PPD/MECHANICAL DEPT.  
BTEV; PIXEL DETECTOR  
CRYO ALUM WINDOW SUPPORT PLATE

SCALE	DRAWING NUMBER	SHEET	REV
FULL	8918.120-MB-407404	1 OF 1	B

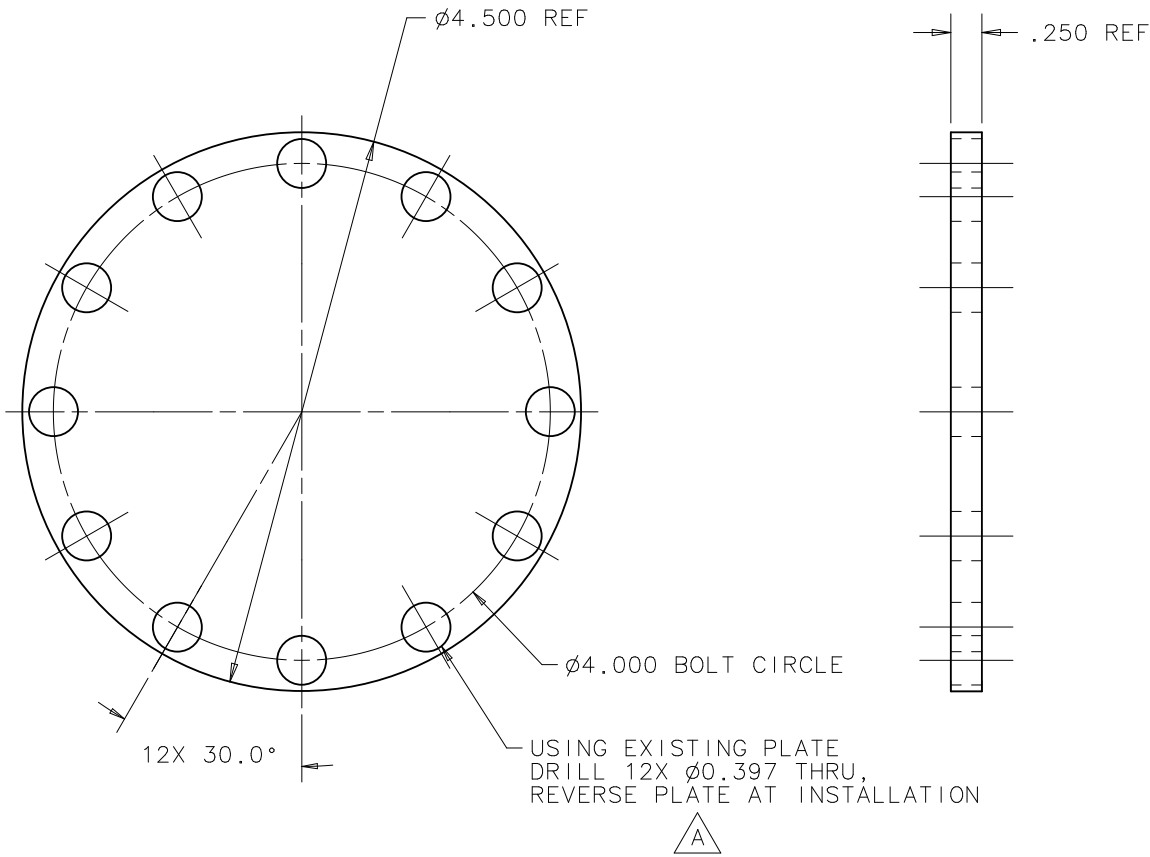
REV	DESCRIPTION	DRAWN	DATE
		APPROVED	DATE
A	ø0.397" HOLES WAS *ø0.332	J. CATALANELLO	04-OCT-2006
		H. CEASE	05-OCT-2006
B	REMOVED ø3.00 HOLE	PAT POLL	10-MAY-2007
		H. CEASE	10-MAY-2007
